Product / Process Change Notification (PCN)

PCN #: PCN_IndPD3_20230727

Affected Series: WE-PD3, size L; 74454xxx

Dimensions: [mm]	
Before change:	After change:

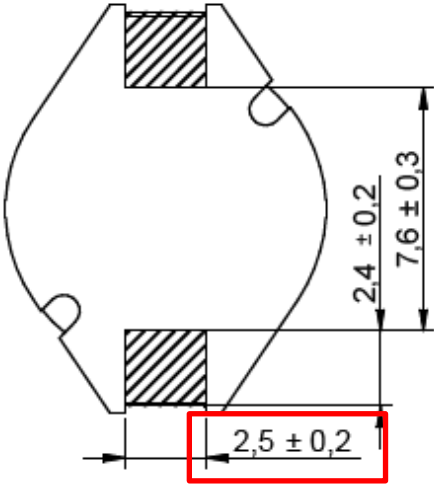
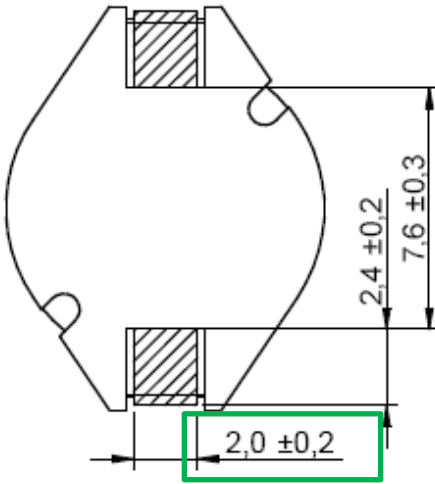
Because of a database mismatch, Würth Elektronik will change the nominal width of the pins from 2.5 mm to 2.0 mm for the WE-PD3 series, size L, with article number range of 74454xxx.
 This is a datasheet correction only. There will be no change in form, fit, function, quality or reliability of the product.
